MEMORANDUM REVISED

Project: The Grove At Shoal
Creek

Re: Review Comments

The Grove at Shoal Creek Planned Unit Development

Figure 5.1: PUD Parks Plan Exhibit

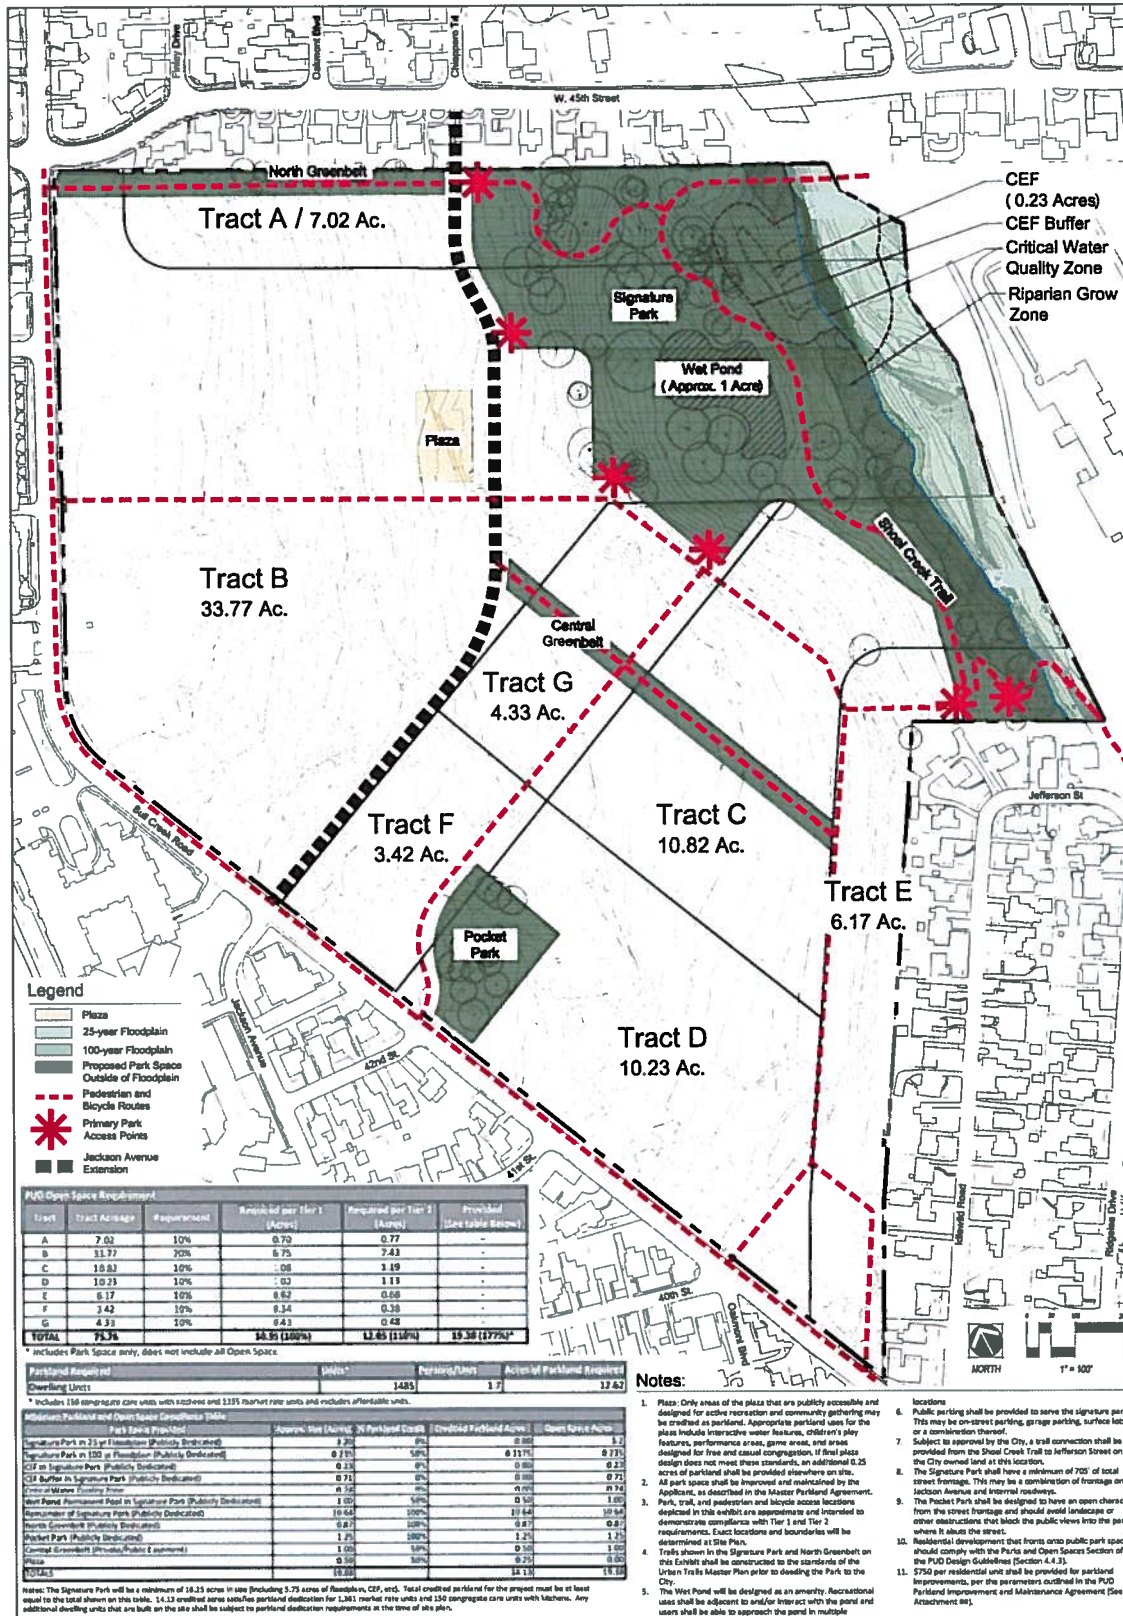
18. The Framework Plan on page 36 of the March 2016 document has been removed because it was redundant. *(Clarification)*
19. The PUD Parks Plan (Figure 5.1 on page 39) has been added to the document. *(Clarification)*
